# Inspection Photos

Operator: SMITH OIL PROPERTIES INC - 79905

API: 123-08177

Inspection Doc. Number: 675103860

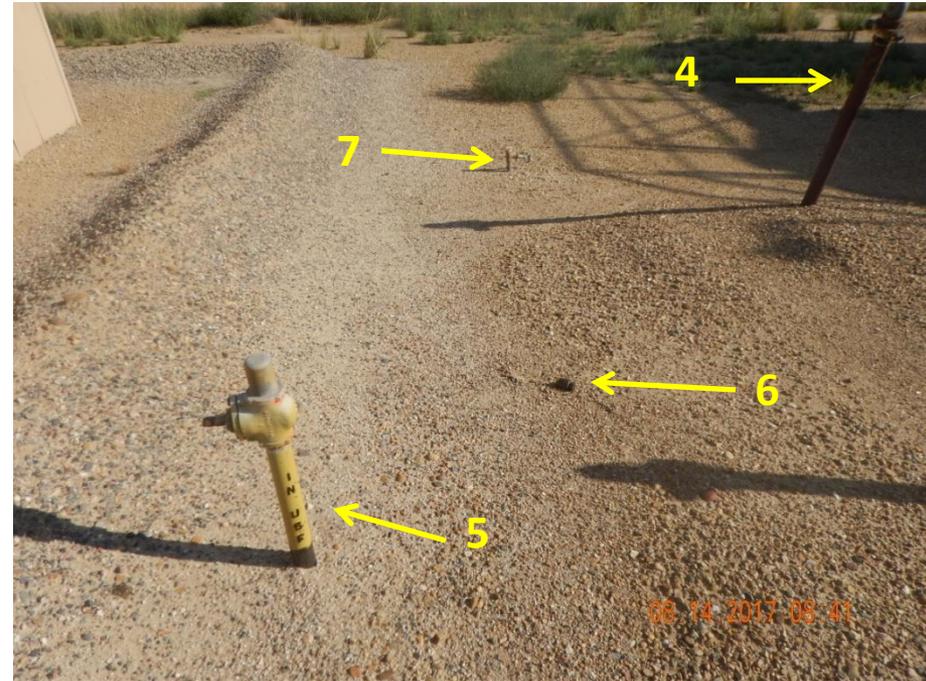
**Photo 3:** Photo taken from the central area of the battery facility, facing north. Photo shows risers at the battery. Inspection doc. #682502037 required operator to comply with reclamation requirements and the 2017 Flowline NTO to remove the risers. Operator appears to have only sprayed "In Use" on five (5) of the seven (7) risers visible (risers labeled 1-5). Risers labeled "In Use" will require pressure testing.
